# CITY OF ALBUQUERQUE

RE: **Lot 16 Block 5 Unit 2 SAD 227**  
**7924 Victoria Rd. NW**  
**Grading and Drainage Plan**  
**Engineers Stamp Date 7/30/2021 (E10D105)**  
**Pad Certification Date 10/27/2021**

## DRAINAGE AND TRANSPORTATION INFORMATION SHEET (REV 6/2018)

ENGINEER'S SEAL 	7924 VICTORIA	DRAWN BY WCUJ
	GRADING AND DRAINAGE PLAN	DATE 4-27-21
DAVID SOULE P.E. #14522	<div>Rio Grande Engineering 1606 CENTRAL AVENUE SE SUITE 201 ALBUQUERQUE, NM 87106 (505) 872-0999</div>	210210044-LAYOUT-4-27-21
		SHEET # — JOB # 21021044

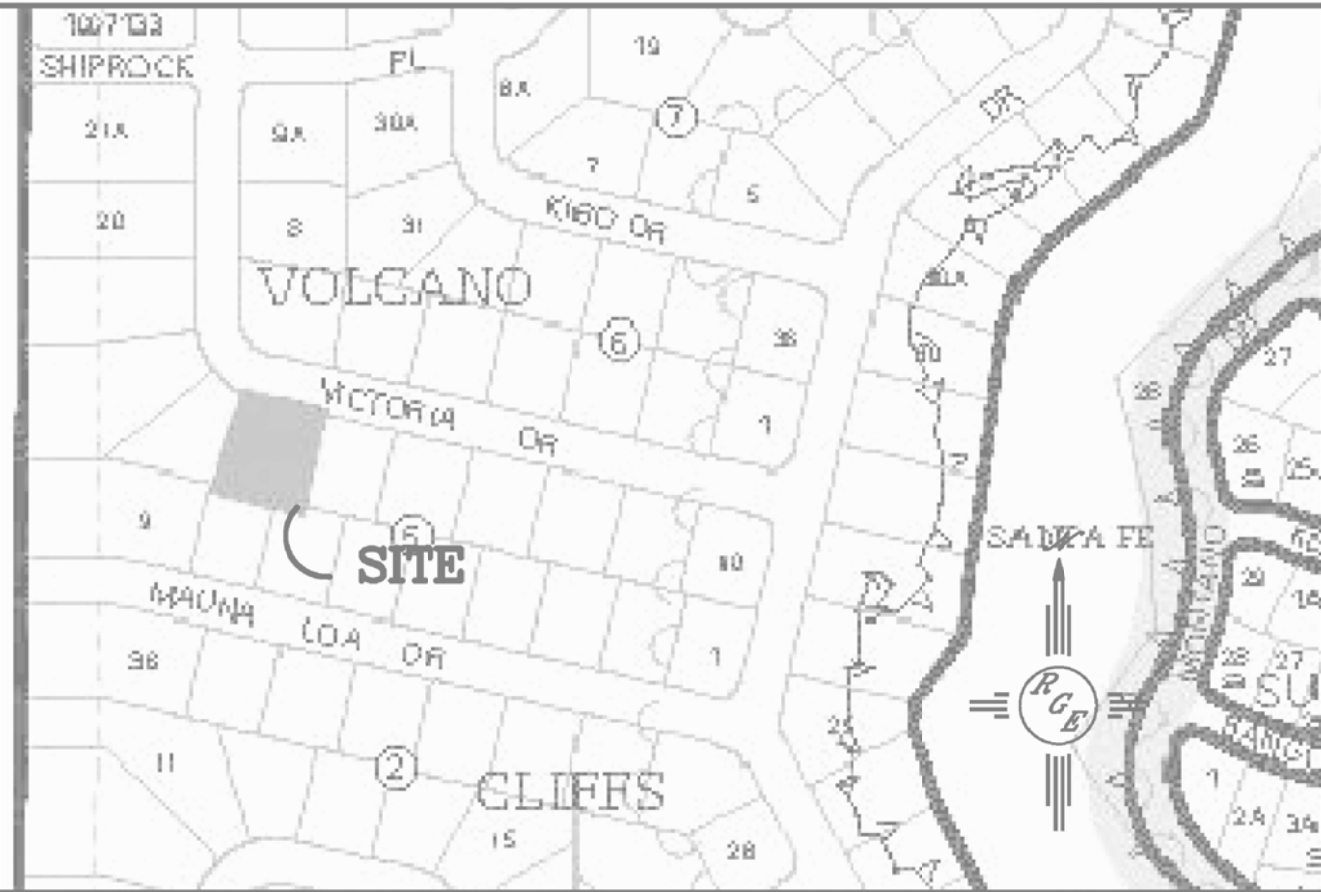
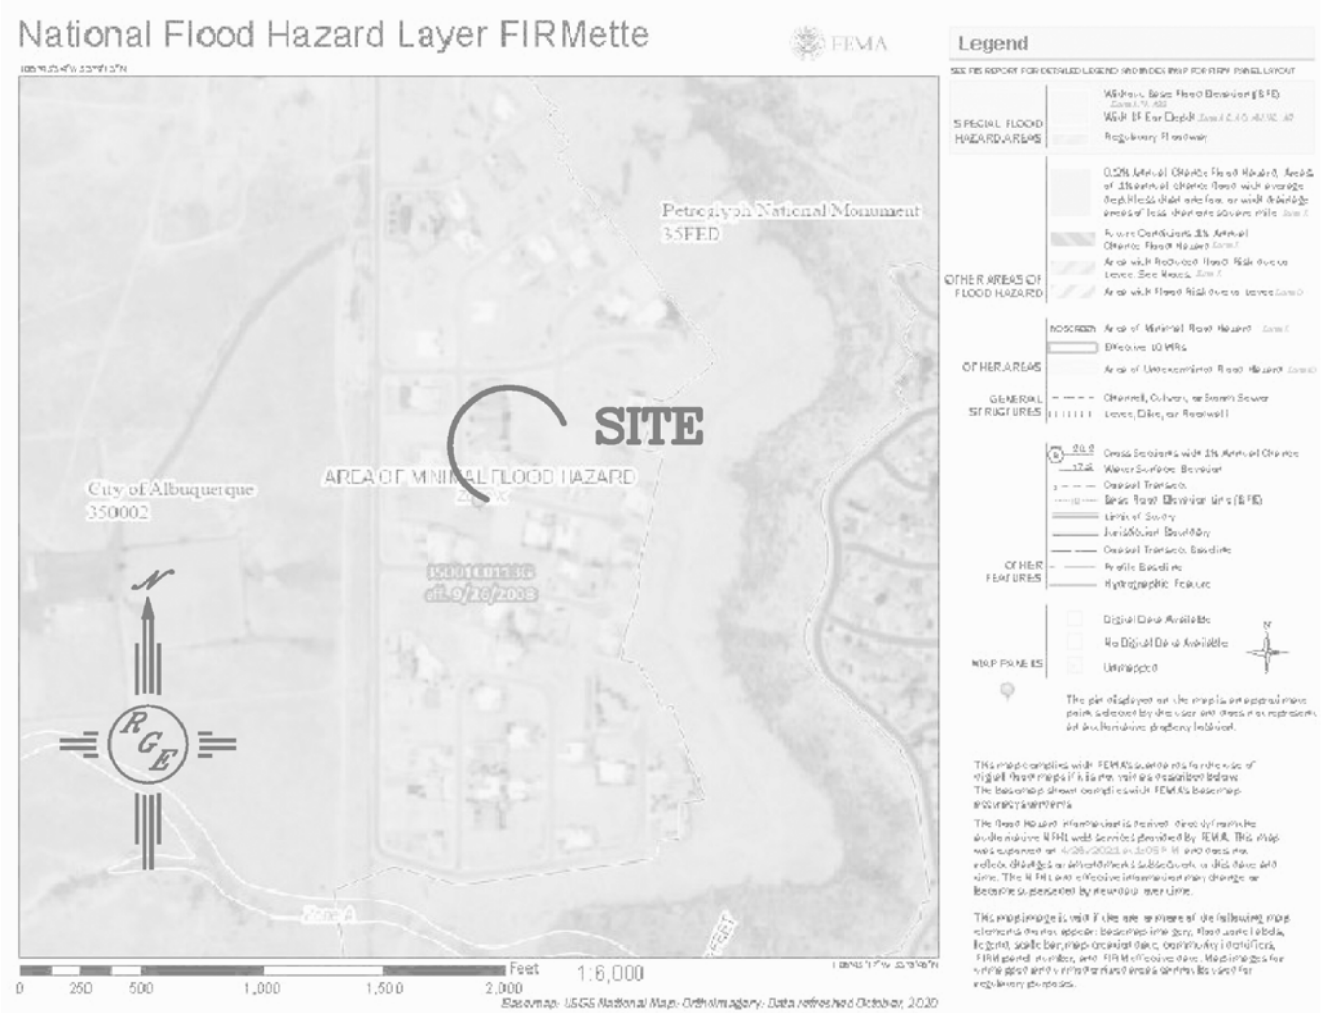
Based upon the information provided in your submittal received 10/28/2021, this plan is approved for Building Permit.

**Reiterate to the Owner/Contractor that a separate permit for a garden/retaining wall must be obtained, with the approved G&D plan. Also, advise the owner/contractor not to use dirt as a ramp to climb the curb. If dirt is used it will cause a delay in permitting.**

Prior to Certificate of Occupancy release, Engineer Certification per the DPM checklist of this plan will be required.
